**Brooklyn Inland Wetlands Commission  
Regular Meeting Minutes  
December 10, 2019**

**1. 102219B Strategic Commercial Realty, Inc., d/b/a Rawson Materials, Maynard Road, Map 29, Lot 5, RA Zone; Excavation of approximately 1.2 million cubic yards of sand and gravel.**

## **ENGINEERING PLAN REVIEW PERTAINING TO STRATEGIC MATERIALS REALTY, INC. PROPOSED GRAVEL EXCAVATION PLAN (ASSESSOR'S MAP 29, LOT 5) MAYNARD ROAD BROOKLYN, CT (December 9, 2019)**

DATE	11-10-78	BY	W. J. HARRIS
PROJECT	KITTLE HYDRAULIC CONNECTIVITY ASSESSMENT CHERRY CREEK P&L		
LOCATION	TOWN OF MADISON, WY		
SCALE	AS SHOWN ON MAP		
FIGURE	2		
DATE	11-10-78

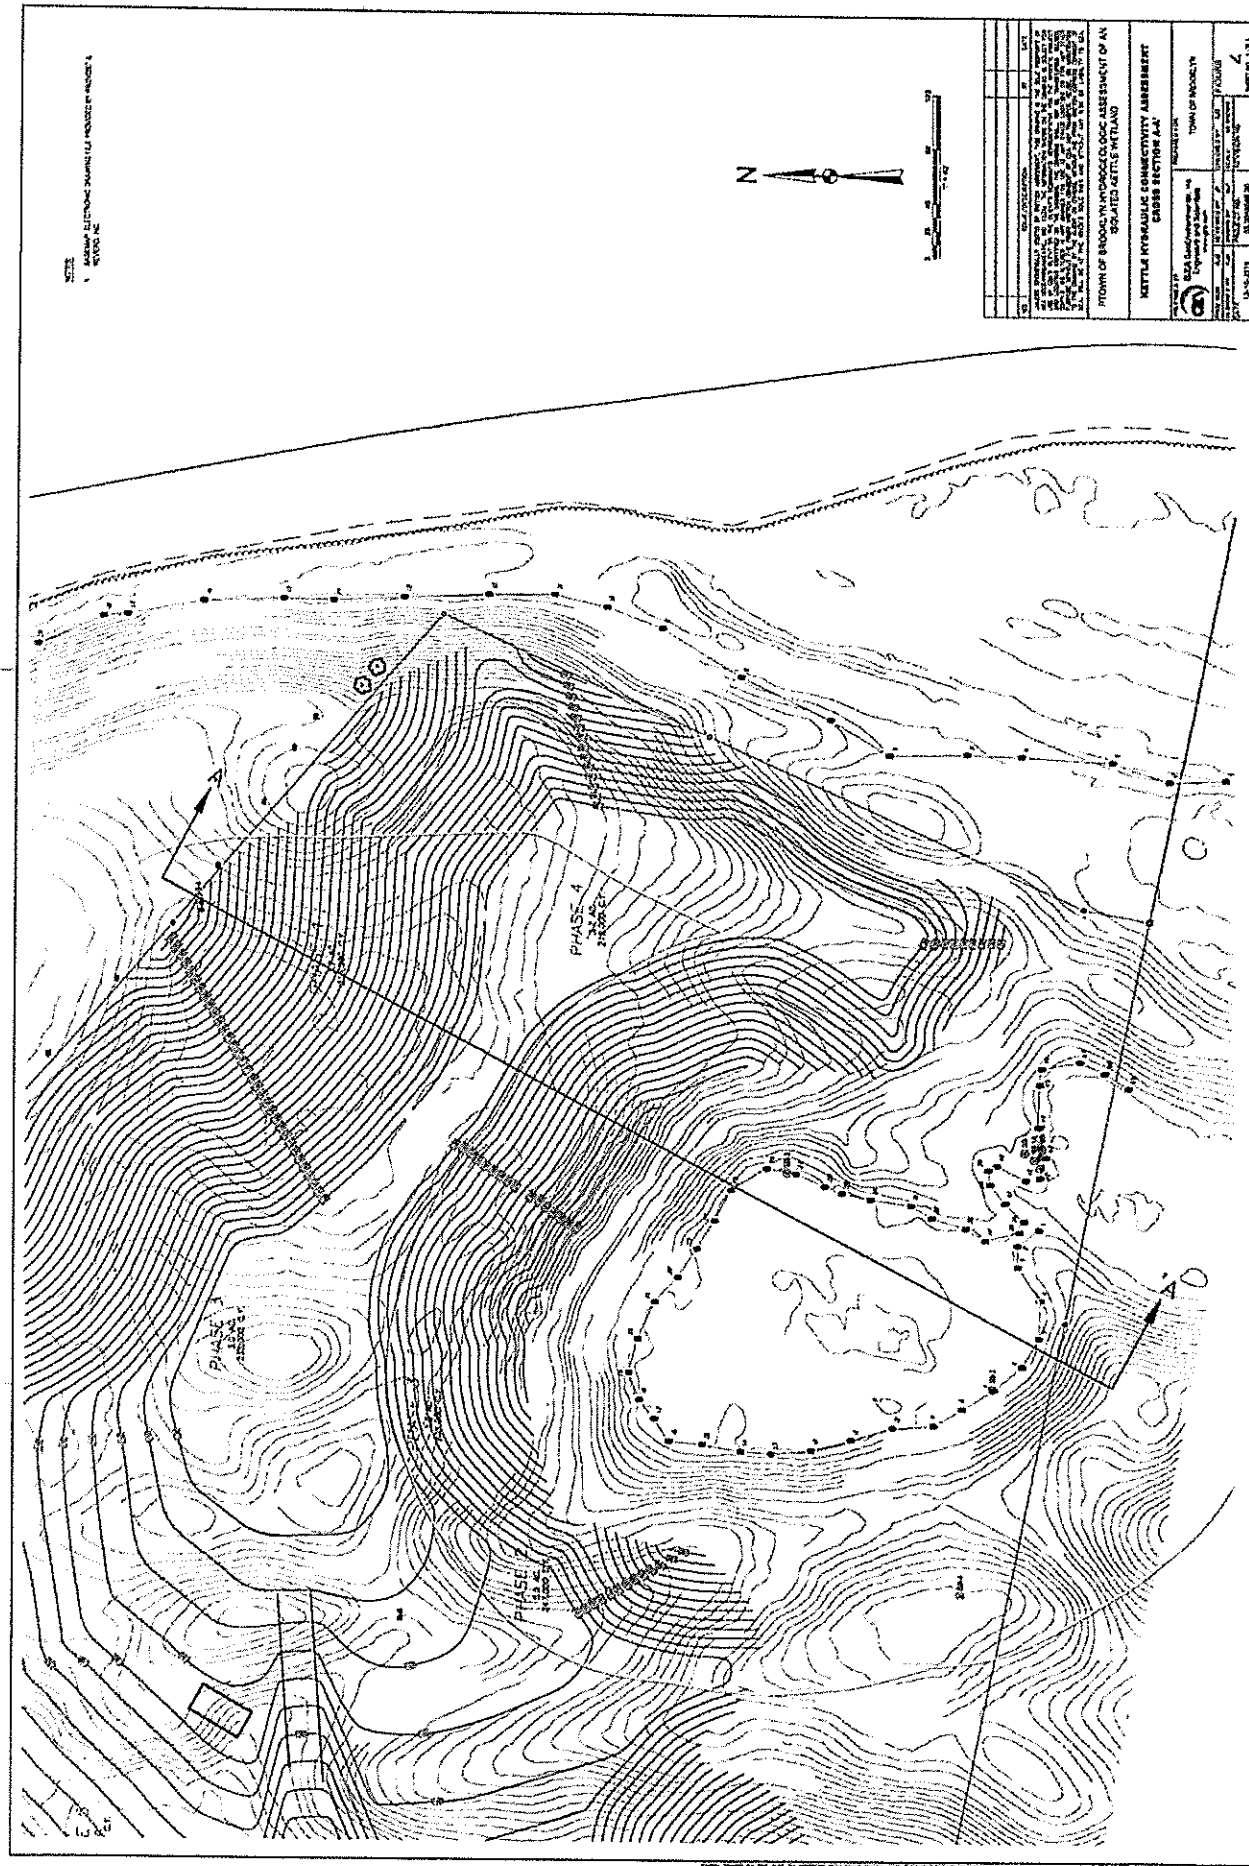
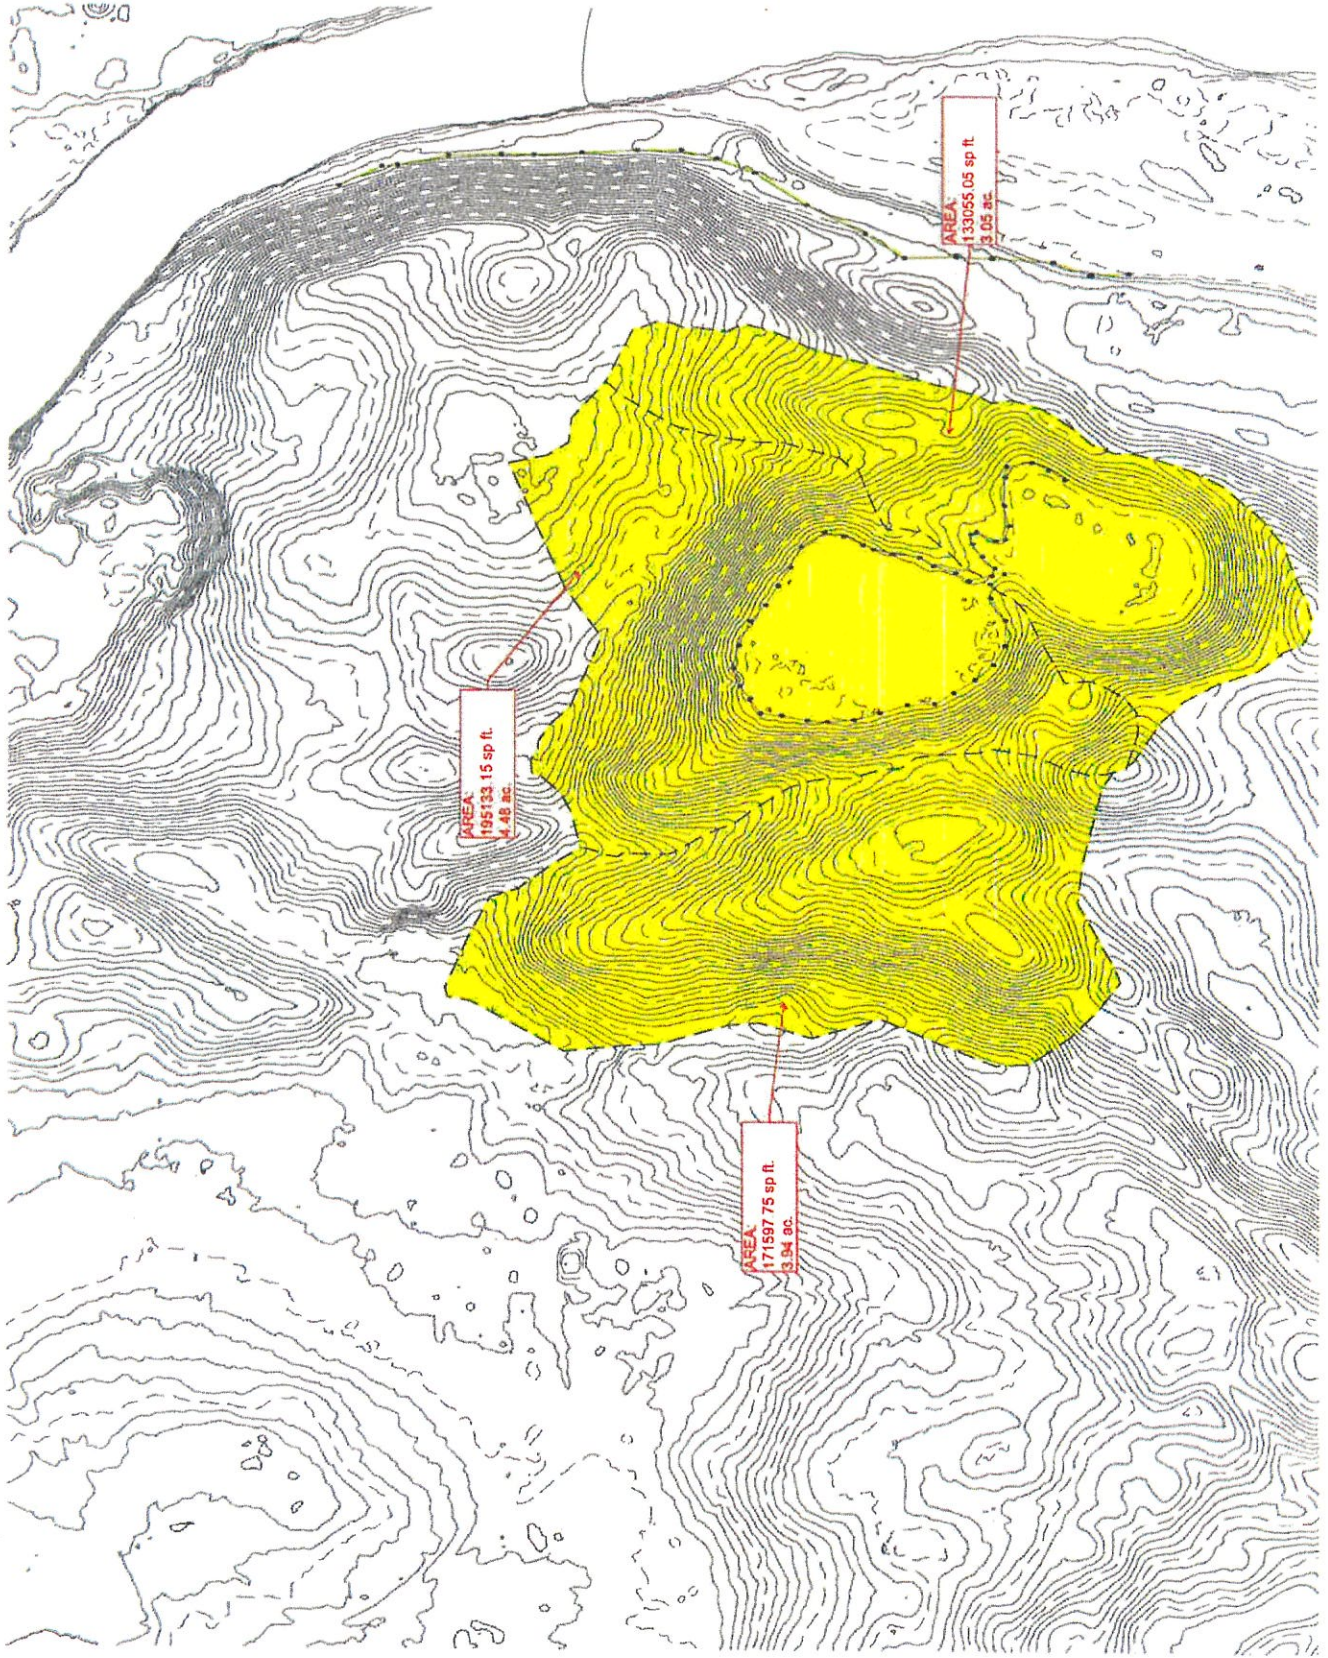
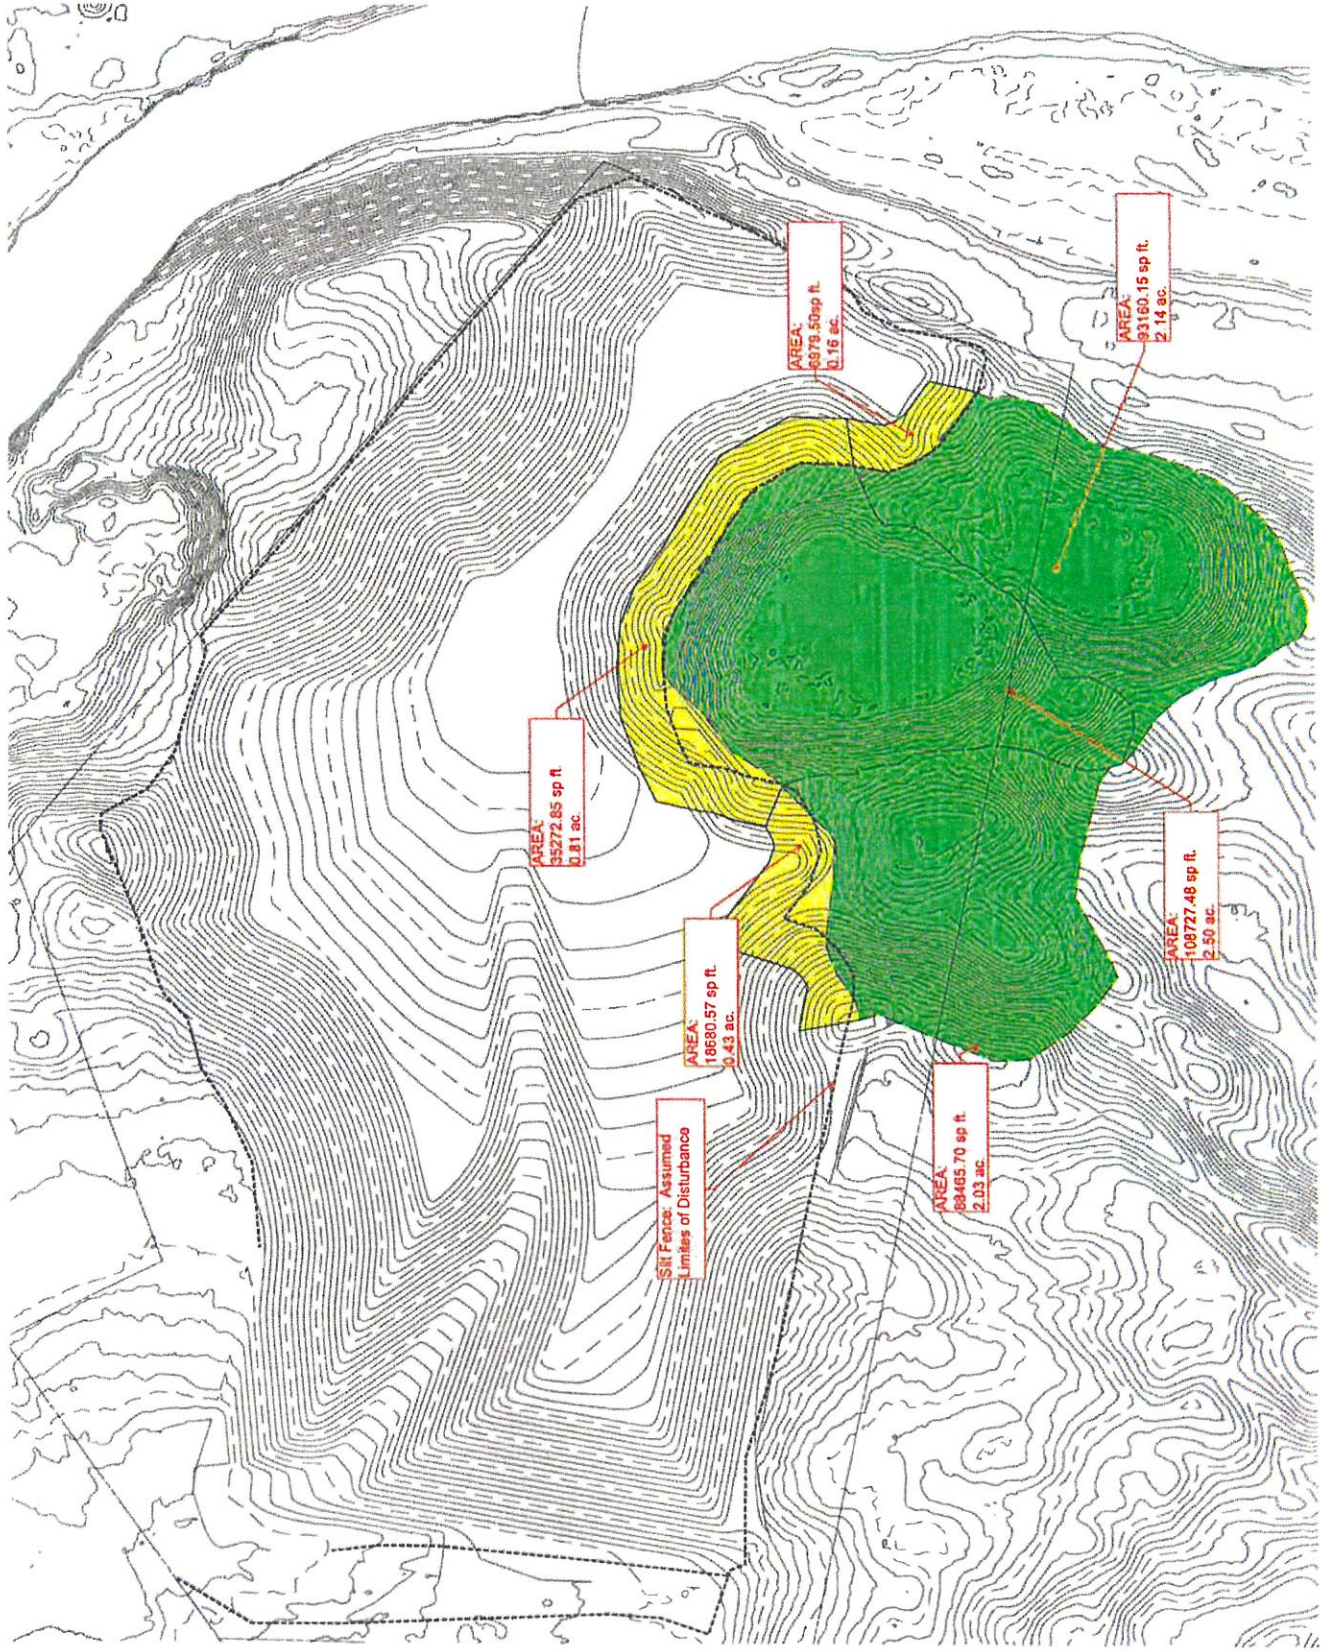
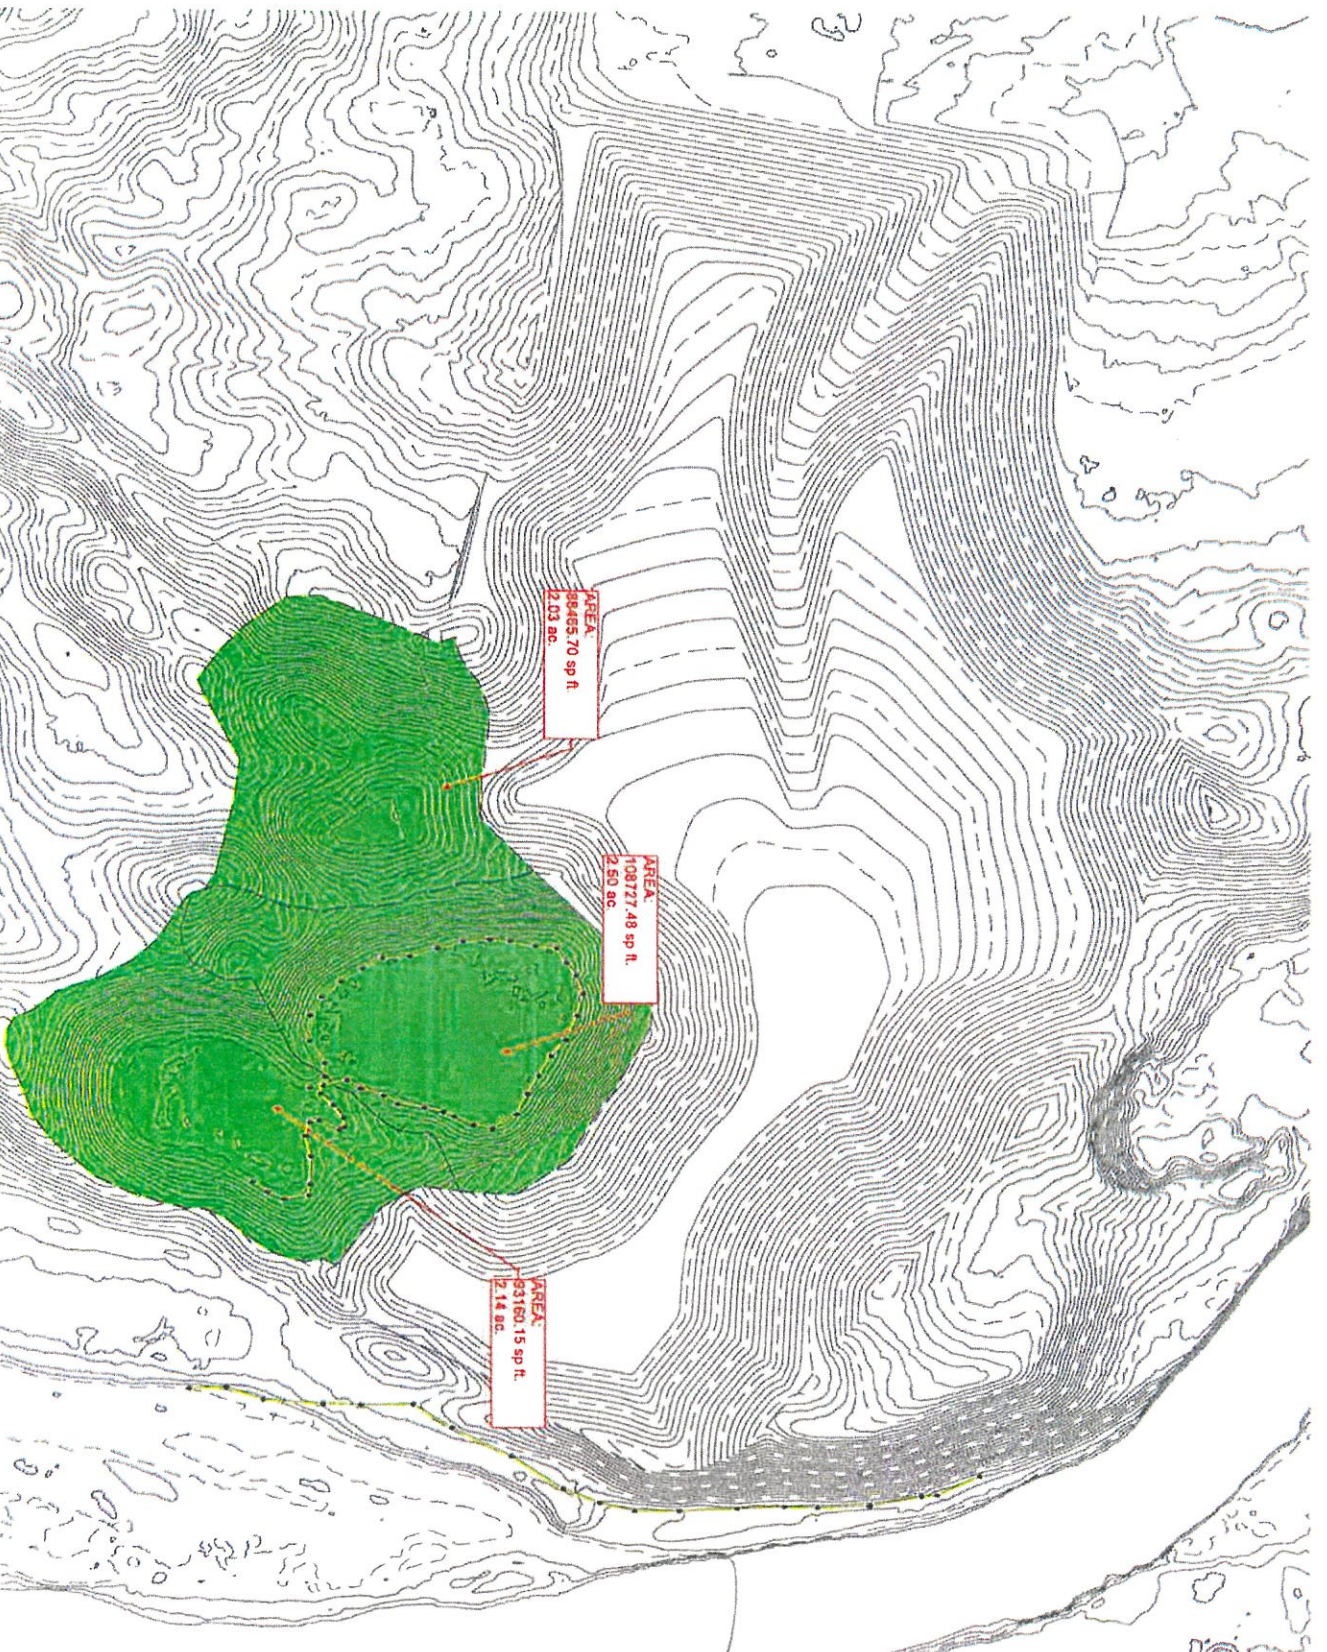
Ms. Washburn asks what is the difference between the 4.6 and the 5.61? Mr. Desrosiers commented that the 4.6 is a 75-foot offset and the 5.6 is a 125-foot offset to edge of wetlands. Mr. Sorrentino asked 75 feet is what the plan proposes now? Mr. Desrosiers commented that is correct.

Looking at the western basin, you can look at the difference between the existing condition, which is 3.9 acres versus a 75-foot offset which is 2.03 acres and if using a 125-foot offset it would be at 2.46, acres. The difference in that is how much water is actually going through the soils. If you think about the kettle wetland as a system, connected seasonally to groundwater, but also potentially perched separately from the ground water, without having any immediate data, they would have to say currently the system is perched based upon the ground water levels at 5 feet deeper. Looking at the system in whole, how does the whole system work? Looking at the area to the north they wanted to see whether or not they would find ground water at below 40 inches below grade, they did not. They found a similar type of hydrology here, demonstrated on the site plan. It is feasible that it is consistent with the ERT Report, that water recharging the individual basins is slowly percolating through the sands and gravels. Sand and gravel are permeable, but we have to remember the glacial ice and how the ice retreated. There are not consistent layers; it is not homogeneous. There are layers in the sand and gravel; some of the layers may be sand, some of them may be sand and gravel, some of them might be silt. Sand and gravel have rapid infiltration. The sand would have a lower infiltration and the silt lower than that. It's been measured that beneath the system there is a silty unit so that has a low permeability. As infiltration of gray water is infiltrated through the sands it will percolate through the sands and gravels. Silty layers will retard the rate the water is moving through, and then that slow rate will then move down into the system and recharge the wetland showing the type of perched condition, maintaining that system the way it is. Without having good information in terms of hydraulics, it is difficult to say where is ground water, is it actually perched, is this intersecting a water table? The applicant has indicated that there was refusal up by the driveway, that was very shallow refusal, that could have been on bedrock; that could have been glacial till. It needs to be understood how the ground water will follow along the impermeable units and how that ground water will recharge this basin itself. Is this basin directly connected to ground water? Is it operating seasonally based on seasonal high water periodically, and recharged by the surrounding soils through the infiltration through these soils? These two things need further evaluation. The information provided is insufficient to make that determination (see attached e-mail 12/10/19).

- Our rough high groundwater estimate suggests that the high groundwater water level, at MW-4, could be at elevation 135.0 ft msl. This is based only on the very limited field data (1 monitoring well and borings terminating on refusal). This well is not located near the kettle wetland resulting in uncertainties at the wetland and for site-wide conditions related to hydraulic connectivity to the kettle wetland.

- The bottom of the excavation may have to be raised, dependent on additional data.
- Our initial assessment suggests that the Town may wish to adhere to the 125-foot setback from the edge of the kettle wetland to maintain adequate precipitation recharge to the kettle wetland.
